The Commission has issued the enclosed Amendments Nos. 39, 37 and 13 to Facility Licenses Nos. DPR-33, DPR-52 and DPR-68 for the Browns Ferry Nuclear Plant, Units Nos. 1, 2 and 3. These amendments consist of changes to the Technical Specifications in response to your request of May 17, 1978 (BFNP TS 109) regarding implant electrical system modifications as described in your letter of May 2, 1978. With your concurrence, we have modified the Technical Specifications to more specifically describe the equipment affected by the modifications.

BROWNS FERRY NUCLEAR PLANT, UNIT NO. 1

Amendment No. 39
License No. DPR-33

SAFETY EVALUATION BY THE OFFICE OF NUCLEAR REACTOR REGULATION
SUPPORTING AMENDMENT NO. 39 TO FACILITY OPERATING LICENSE NO. DPR-33
AMENDMENT NO. 37 TO FACILITY OPERATING LICENSE NO. DPR-52
AMENDMENT NO. 13 TO FACILITY OPERATING LICENSE NO. DPR-68
TENNESSEE VALLEY AUTHORITY
BROWNS FERRY NUCLEAR PLANT, UNITS NOS. 1, 2 AND 3
DOCKET NOS. 50-259, 50-260 AND 50-296

Figure 1

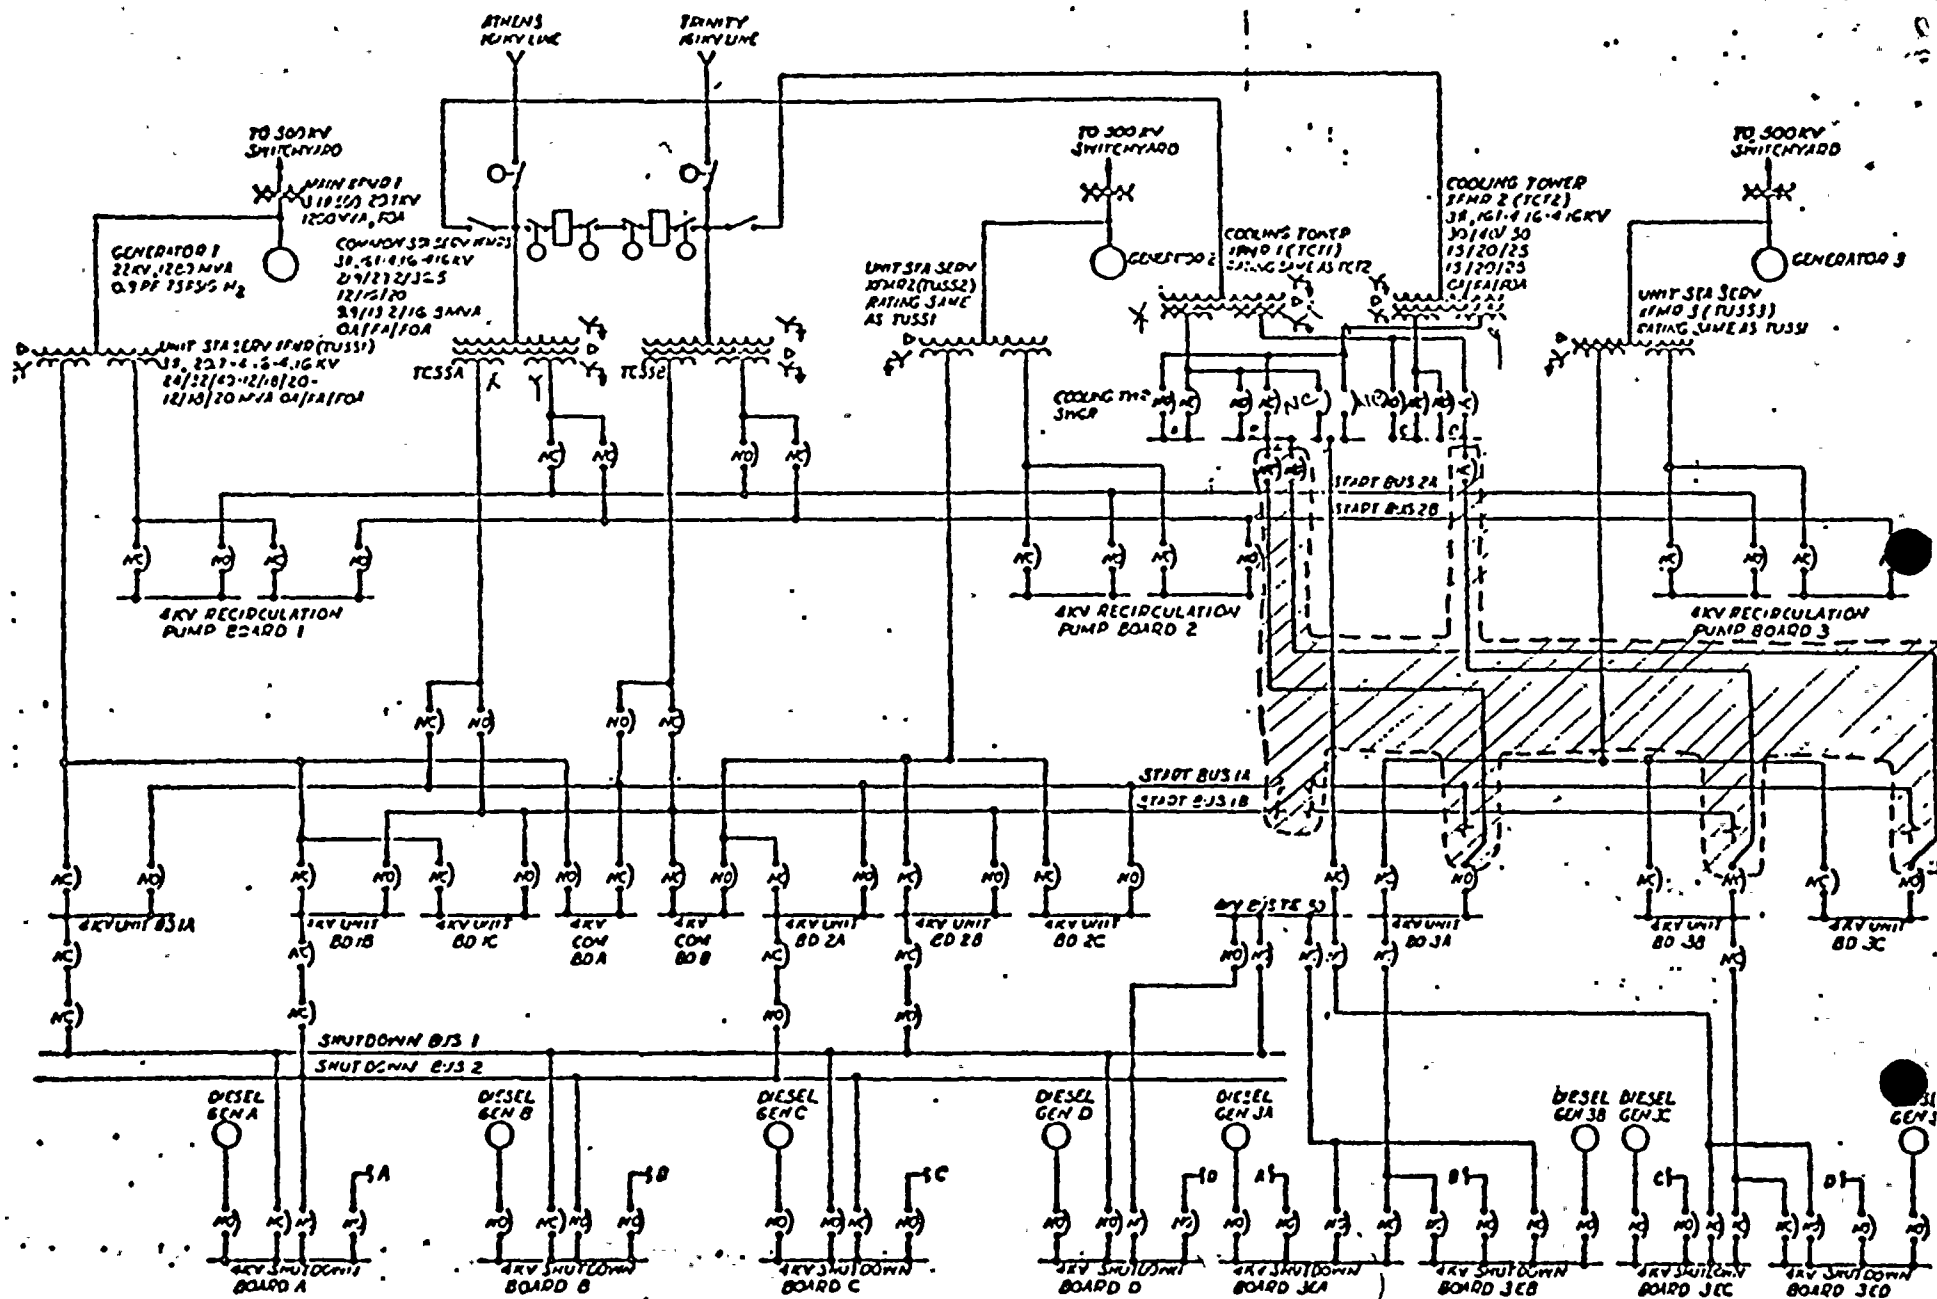
Unit 3 boards 3A, 3B, and 3C will be cut off the start bus 1A and 1B and will be supplied from cooling tower transformers 1 and 2 as shown in the cross-hatched portion of Figure 1. The offsite supplies for shutdown boards 3EA and 3EB, and for shutdown boards 3EC and 3ED are fed through board 3A and 3B, respectively. The 4kV bus tie board can be supplied power by either of the cooling tower transformers and remains unchanged from the original design.

The feeder cables for these offsite power supplies are routed in separate cable trenches to the cooling tower transformers. The system modifications also improve the power factor on the offsite power source by installing the capacitor banks on 161 kV line, and reduce the voltage drop on the inplant system by rearranging the 4160 volt loads to common station service transformers and cooling tower transformers. The modified configuration would result in a voltage of 3950 volts on 4160-volt inplant system for the postulated events.

The staff has reviewed the licensee's proposed modifications to the plant system - the installation of two capacitor banks and the rearrangement of the Unit No. 3 4160 volt loads to improve the inplant system voltage. The staff also reviewed the associated changes to the Technical Specifications resulting from these modifications. Based on the evaluation of the information provided by the licensee, the staff concludes that the proposed system modifications are an acceptable method of assuring that the inplant system voltages satisfy the requirements of General Design Criterion 17 with regard to system capacity and operability. With the changes we have proposed and which the licensee has accepted, the staff finds the changes to the Technical Specifications to be acceptable.
